Is Empshott Grange a *safe* school location?

An evidence-based review of traffic, carriageway geometry and network resilience on the B3006, Mill Lane and Church Lane.

Proposed school development at
Empshott Grange

Highway safety & network resilience

Applicant's swept-path analysis depicts simultaneous passing at a 3.35 m pinch point

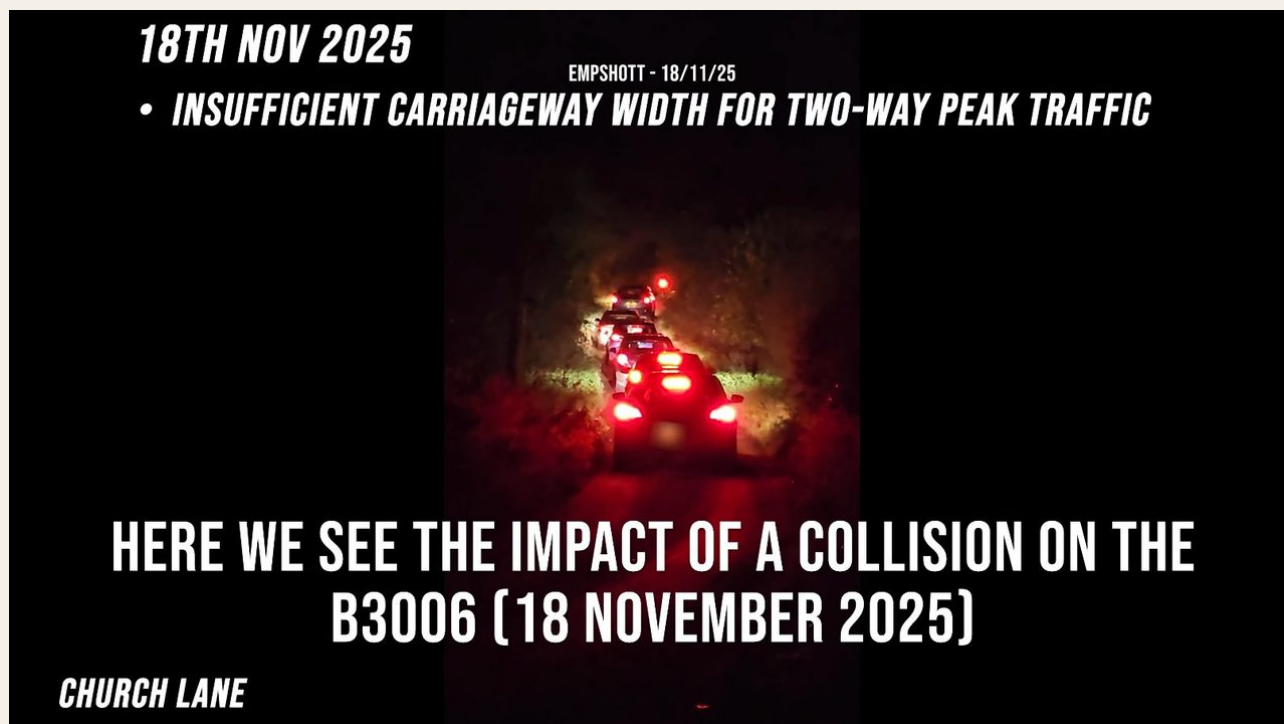
The photographs above record the measured carriageway width of approximately 3.35 m at this point on Mill Lane, alongside the roughly 4.5 m that two vehicles would actually need to pass. This is the same point through which the applicant's swept-path analysis depicts two opposing vehicle movements.

The applicant's own stated vehicle widths are 2.06 m for the L3 H3 Ford Transit and 1.80 m for the SDV, giving a combined body width of 3.86 m, excluding mirrors (Additional Highways Plans, SDNP/25/03084/FUL).

The combined stated body width therefore exceeds the measured carriageway width by approximately 0.51 m before any allowance is made for wing mirrors, clearance between the vehicles, or clearance from the edges of the carriageway. In practical terms, the discrepancy would be greater once mirrors and even a minimal passing gap were taken into account.

This raises an important question as to how the simultaneous swept paths shown on drawing TR/06 can be reconciled with the physical dimensions of the highway at this location.

This is particularly relevant because Hampshire County Council Highways expressly refers to TR/06 in its substantive consultation response and states that the drawings show a minibus and car, and two minibuses, passing simultaneously along Church Lane. Although the measured pinch point is on Mill Lane immediately beyond the Church Lane junction, the swept paths shown on TR/06 continue through the junction and across this location.

If two vehicles meet at this 3.35 m pinch point, the applicant's own dimensions indicate that they cannot simply pass one another. One vehicle would have to stop, wait, reverse or find a wider location. With substantially increased movements concentrated into the school arrival and departure periods, this creates a clear risk of recurring vehicle conflict and localised queuing close to the Church Lane/Mill Lane junction.

Are Hampshire County Council Highways aware that simultaneous passing at this specific point appears to be physically impossible, despite the submitted swept-path analysis depicting opposing vehicle movements through it? If so, has the operational consequence of vehicles having to stop, wait or reverse at this pinch point been specifically assessed when considering the proposed increase in school traffic?

Nobody can get in or out of the village

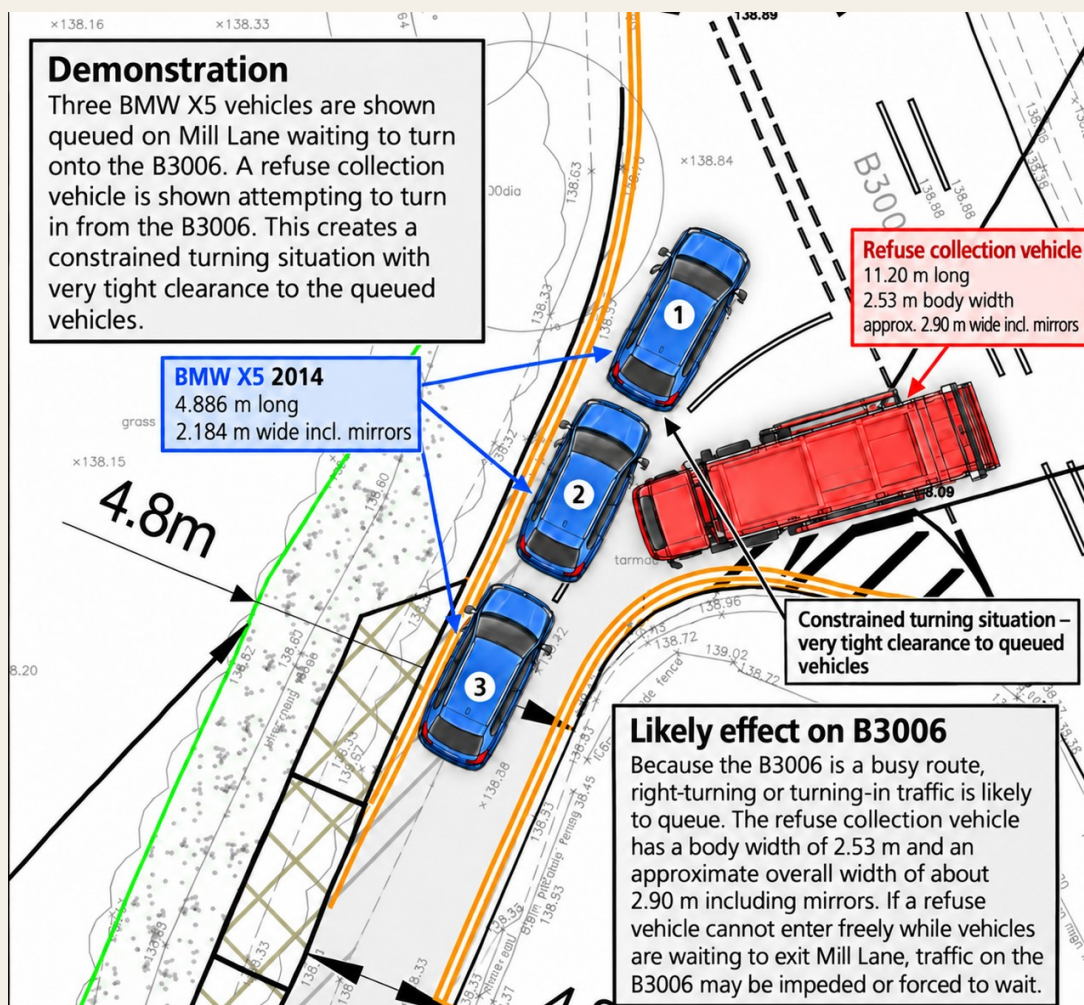
Following a collision on the B3006, traffic was diverted onto Church Lane — a lane that cannot carry two-way flow. The diverted two-way traffic met head-on with nowhere to pass, and the result was gridlock (recorded here at 06:50). Each time the main road fails, the village lanes inherit traffic they were never built to take.

A road already carrying far more than it was built for

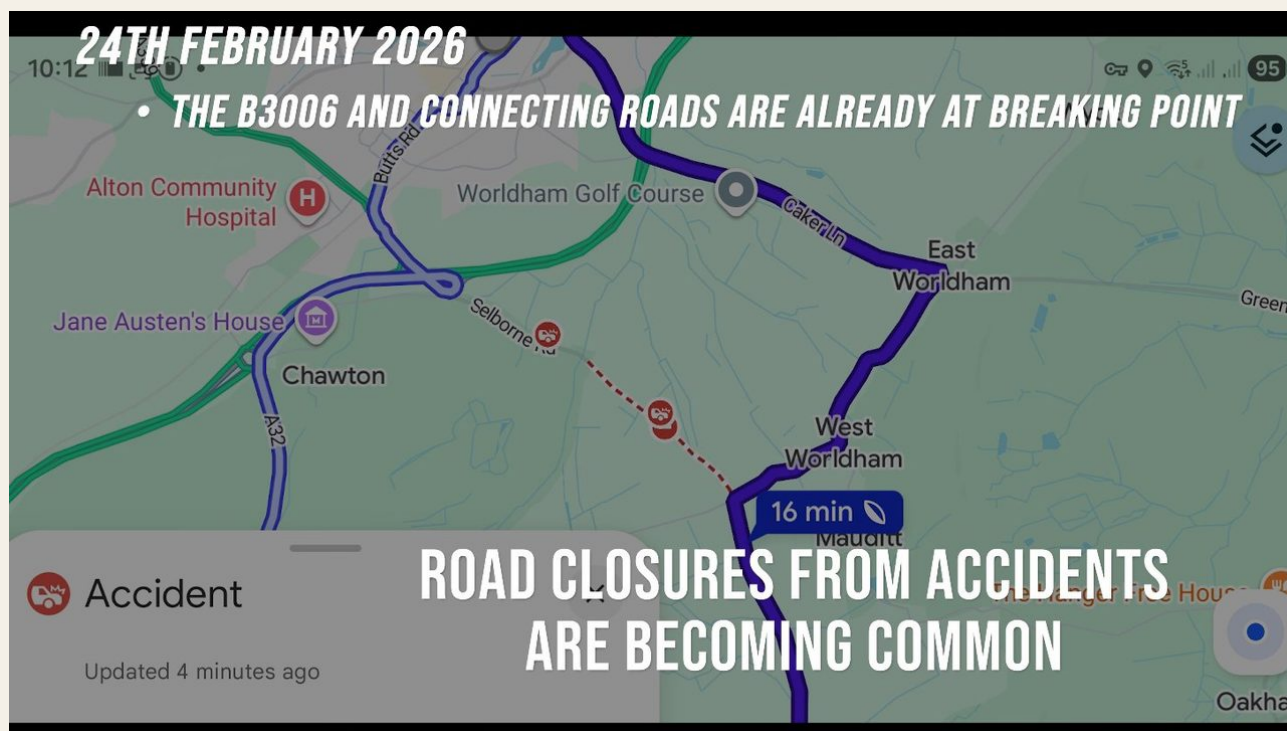
The B3006 is a rural B-road now carrying heavy commuter flows: traffic has risen by more than 1,000% since the early 1990s, taking it beyond the capacity it was designed for. At peak times it queues; on the morning of 3 February 2026 traffic stood nose-to-tail along its length. Adding a new traffic generator to a road already beyond its design capacity compounds a problem the network cannot absorb.
